**PLANNING ACT 2008
APPLICATION BY HIGHWAYS ENGLAND FOR AN ORDER GRANTING DEVELOPMENT CONSENT FOR THE A303 SPARKFORD TO
ILCHESTER DUALLING**

SUBMISSION MADE PURSUANT TO DEADLINE 5

South Somerset District Council's Response to the Examining Authority's written questions and requests for information (ExQ2)

South Somerset District Council's Hearing Action Points for D5

Hearings Action Points 31

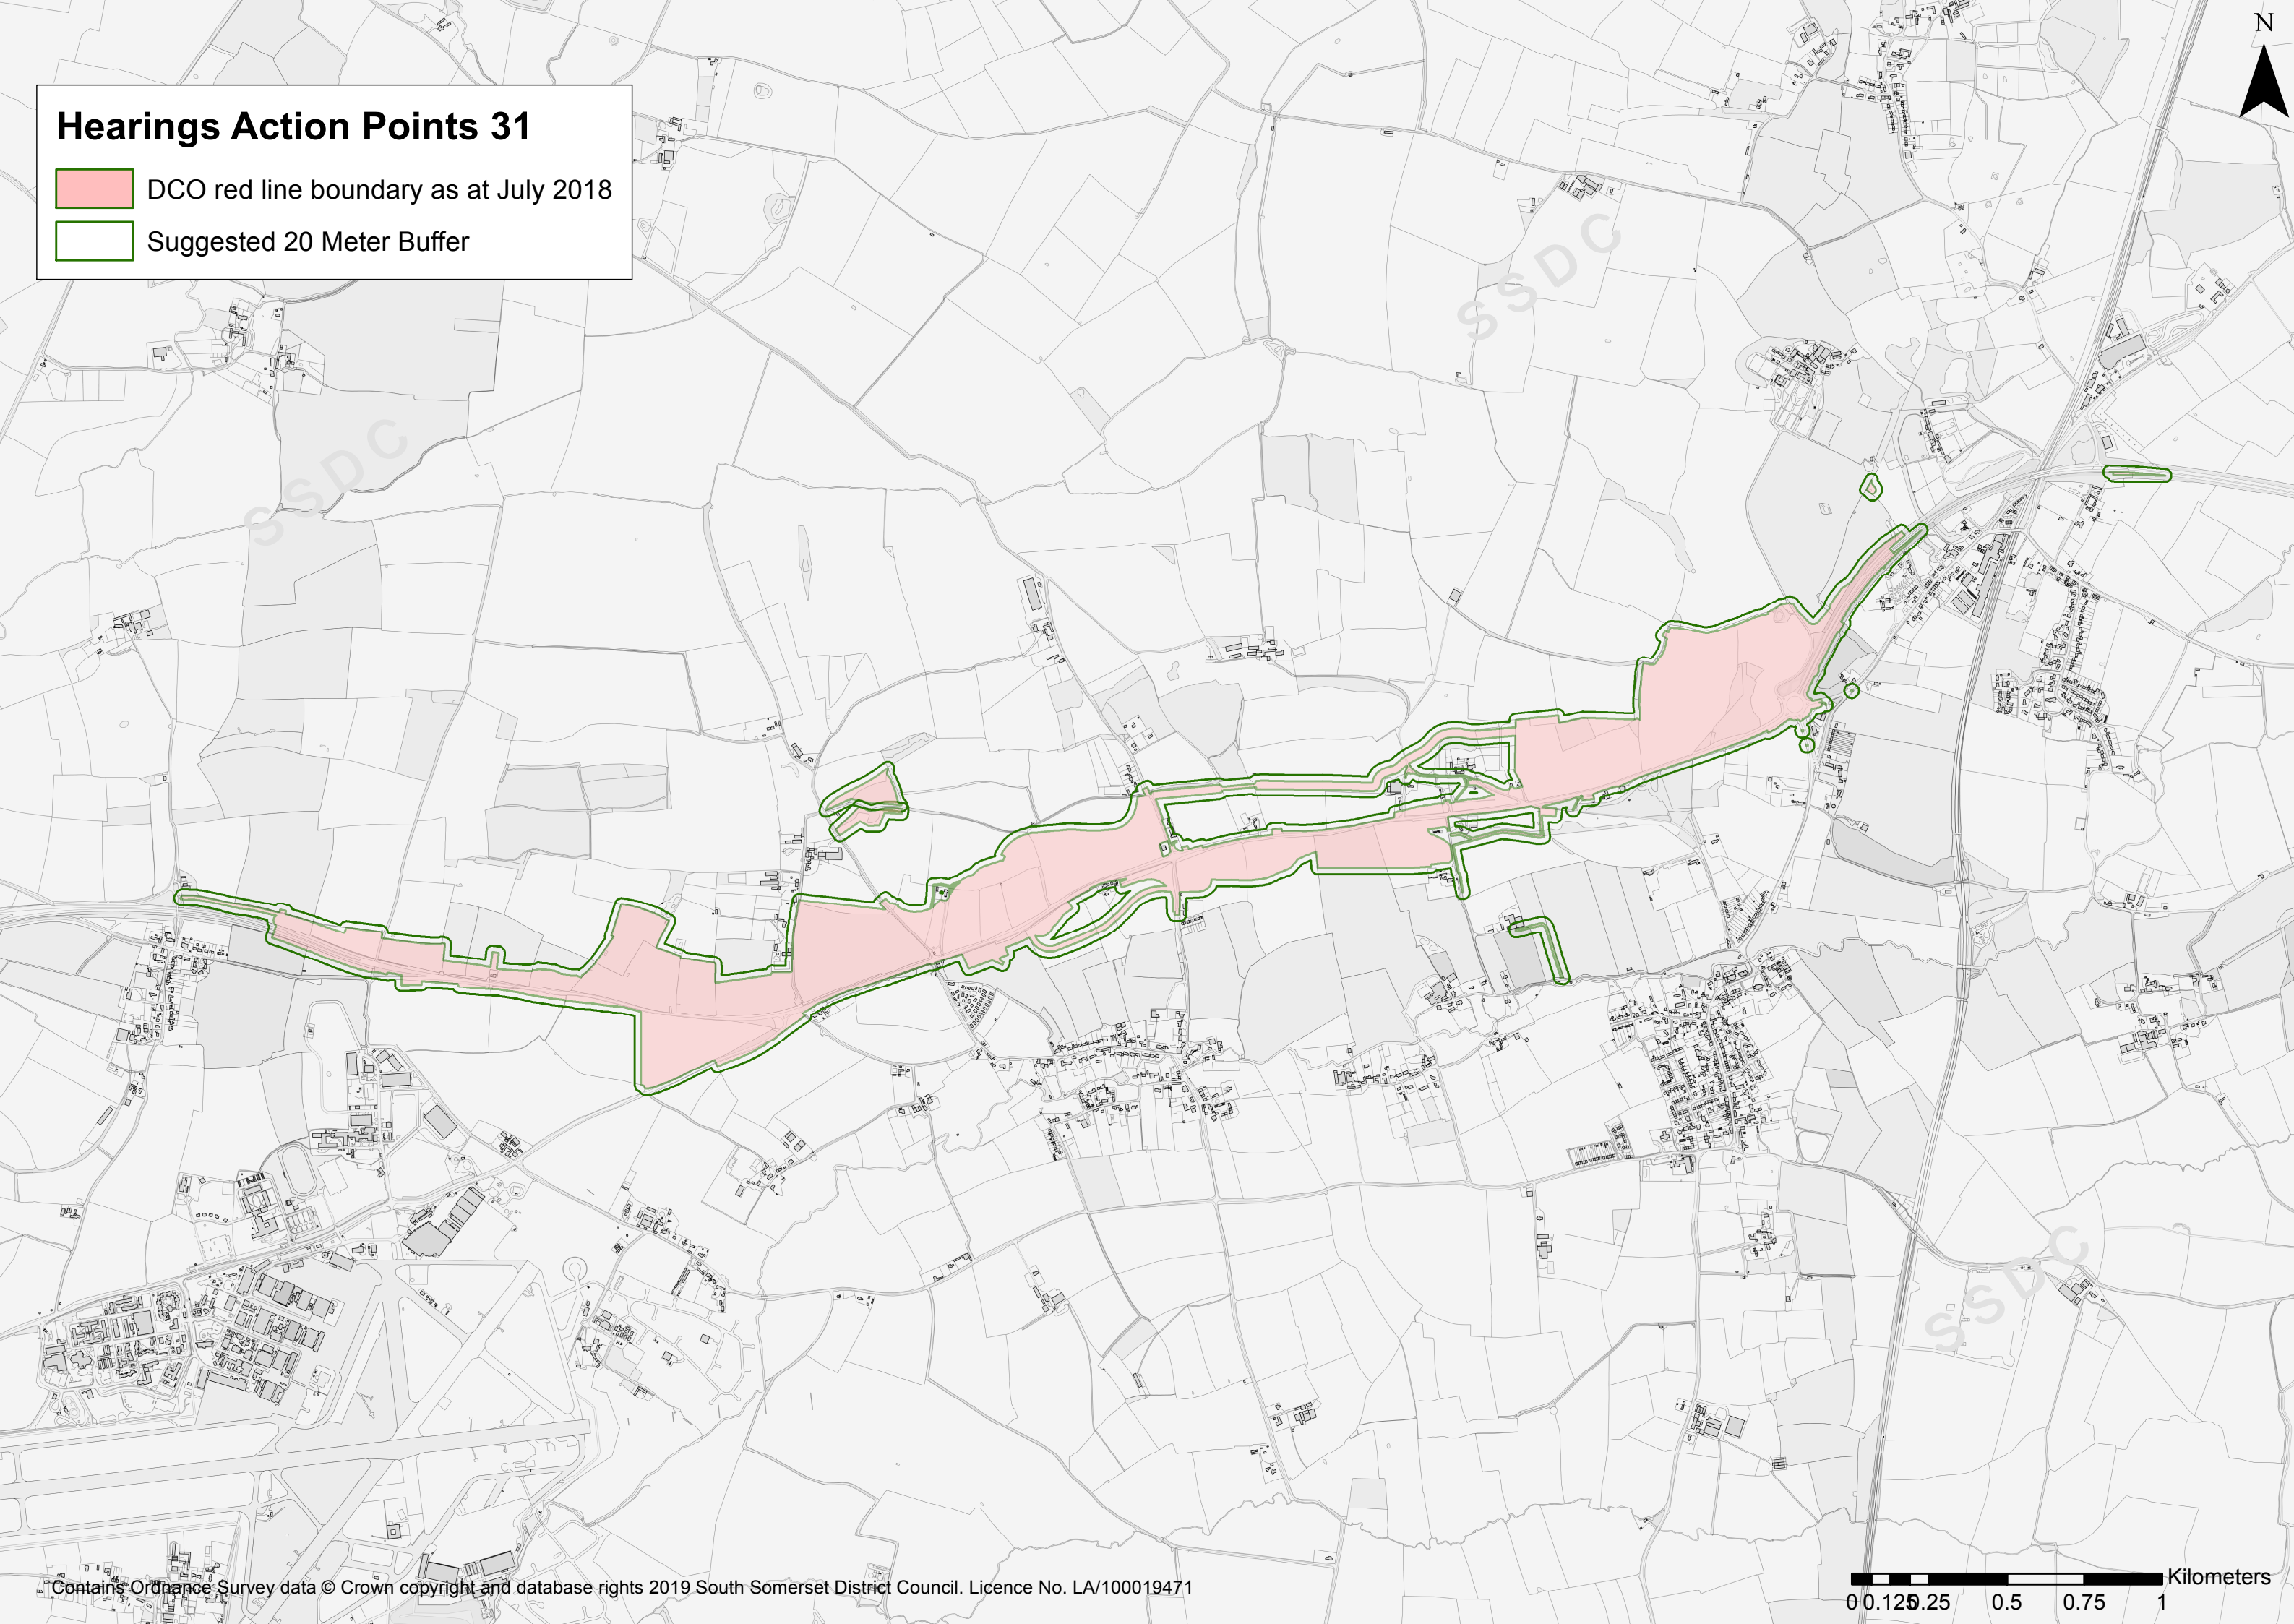
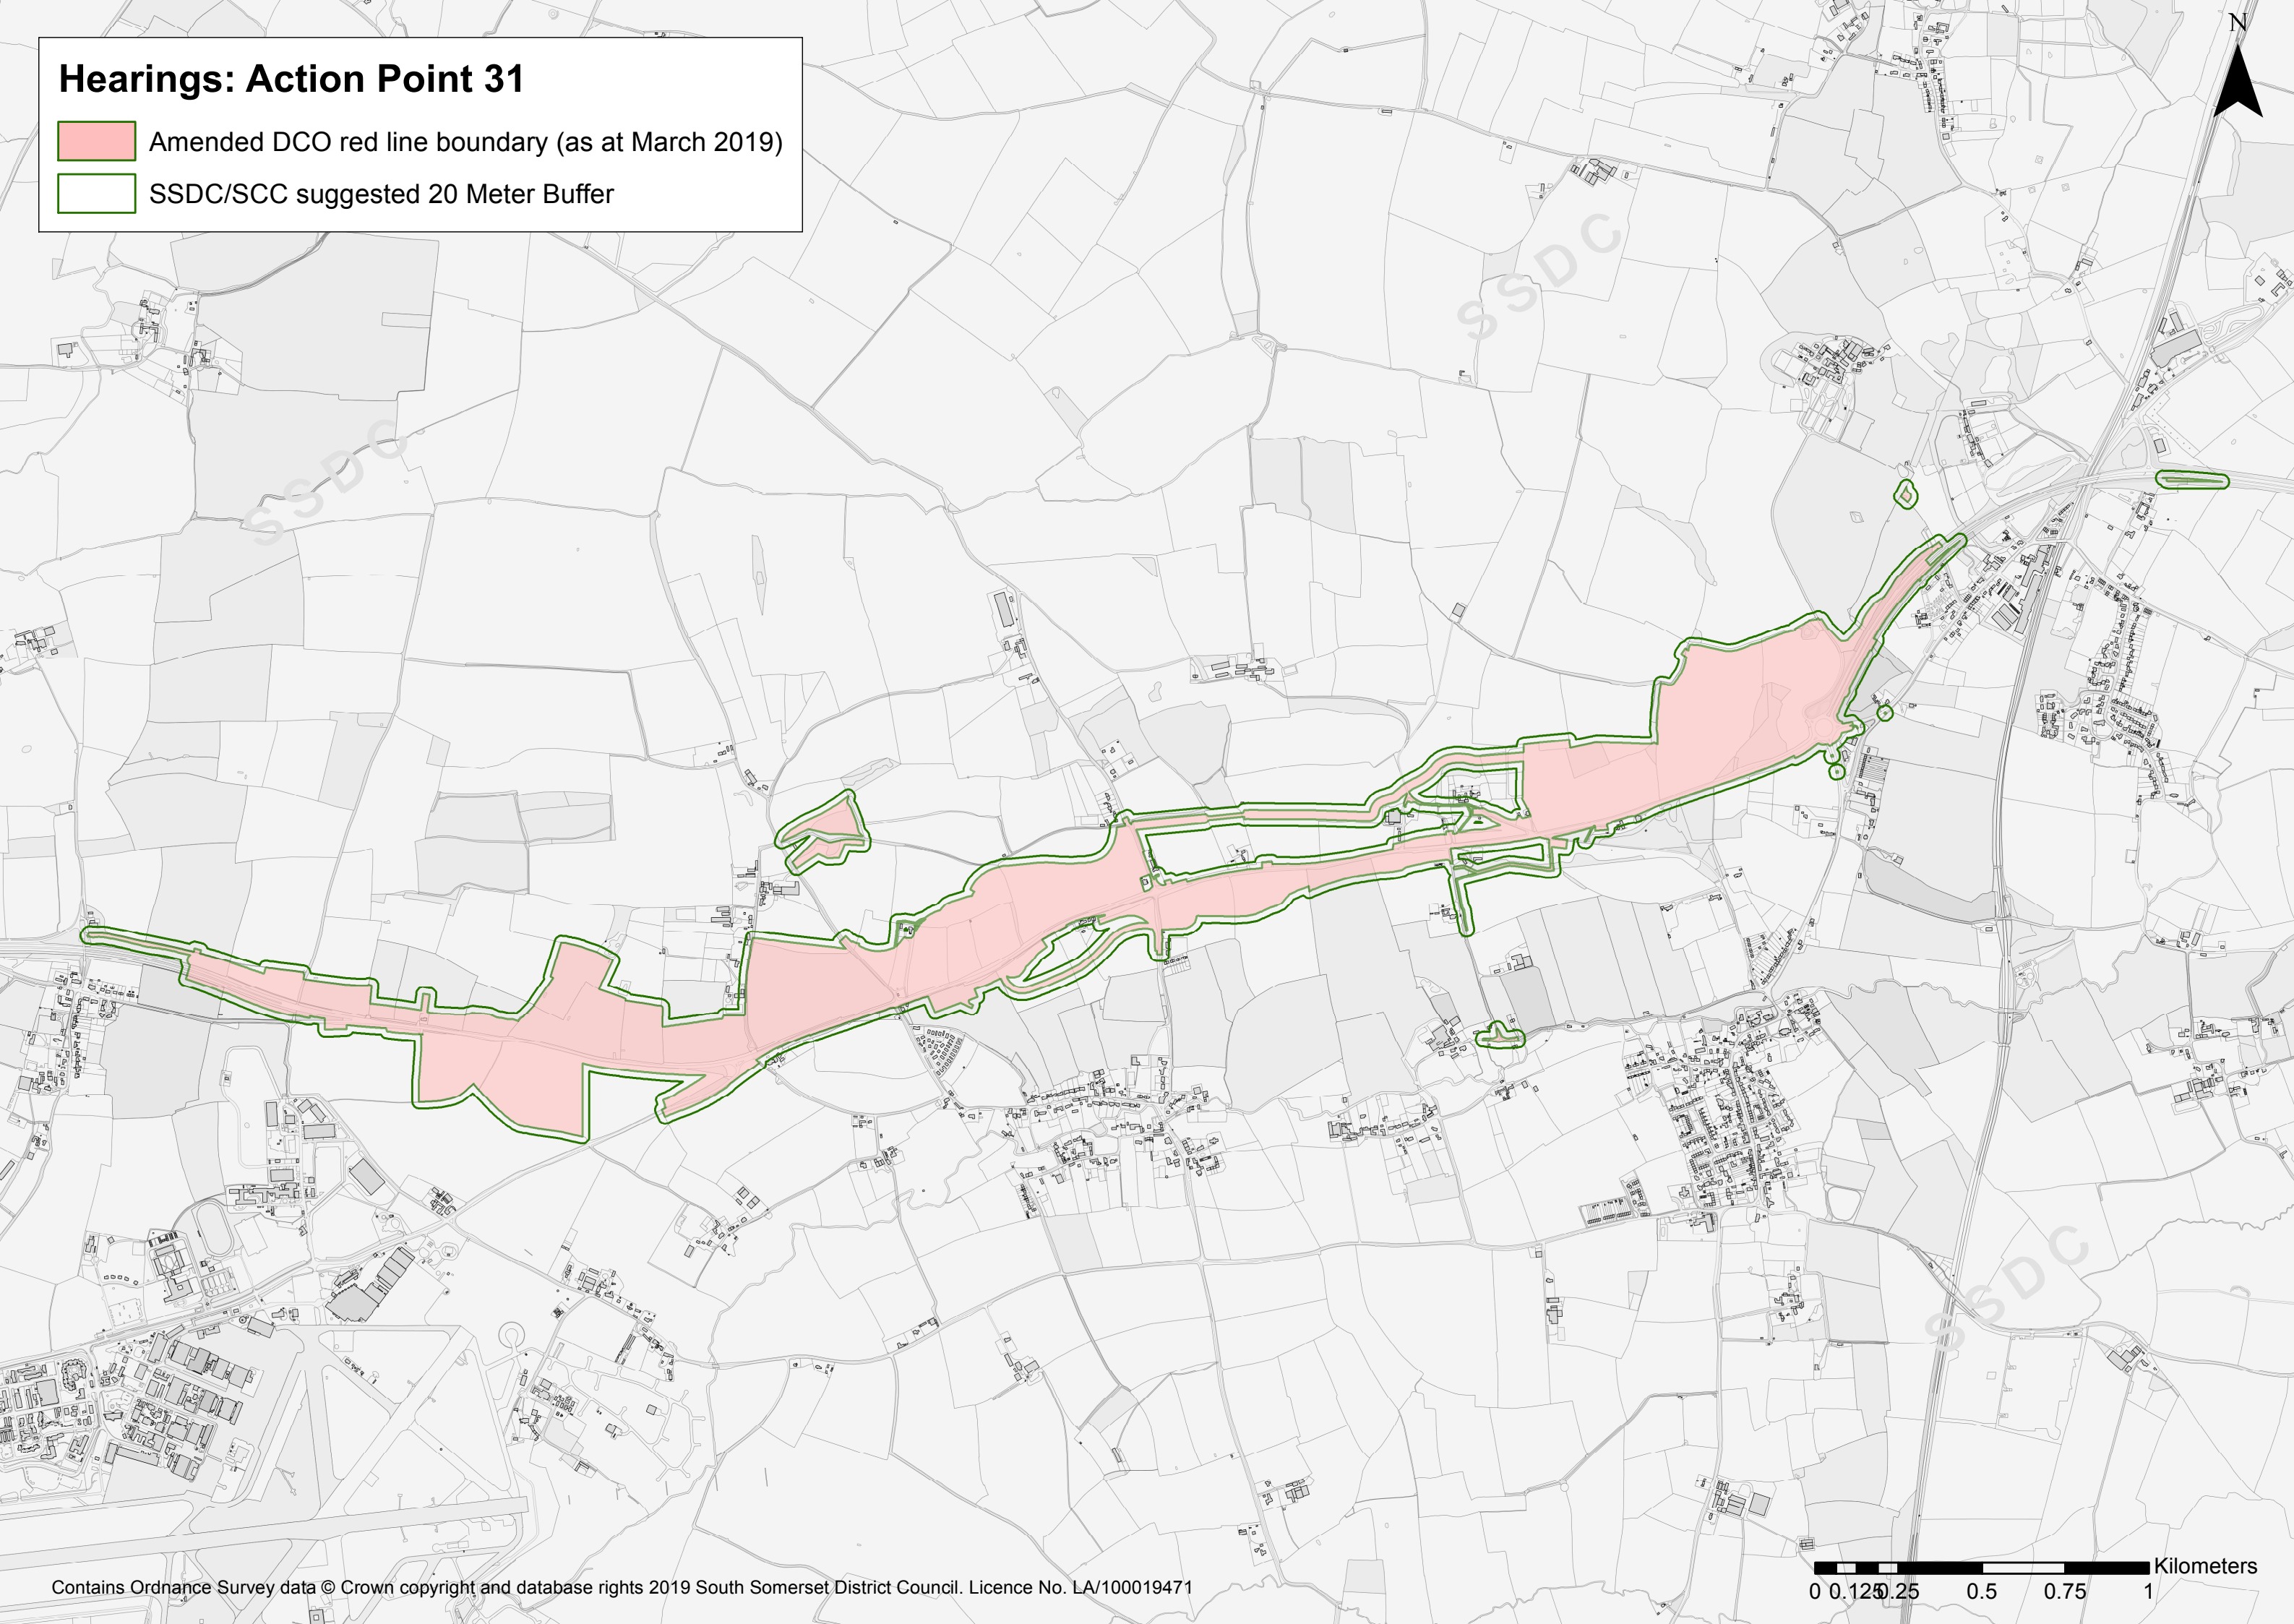
As raised during the hearing, the Council would seek to define “adjacent” by means of a boundary. The Council is now submitting for consideration a map which identifies the boundary of adjacent as a 20 meter perimeter around the Order Limit. The plan has the benefit of clearly identifying the extent of the area in question which will be crucial for enforcement purposes and currently lacking in the definition proposed by the applicant.

The purposes for which the power could be used is considered to be wide and should be clarified. It might be acceptable to have some limited temporary powers over land adjacent to the Order Limits for purposes of allowing the development to be completed but the District Council does not consider, as suggested by the applicants, that it should be permissible for this power to extend to, amongst other things, amending speed limits through the villages.
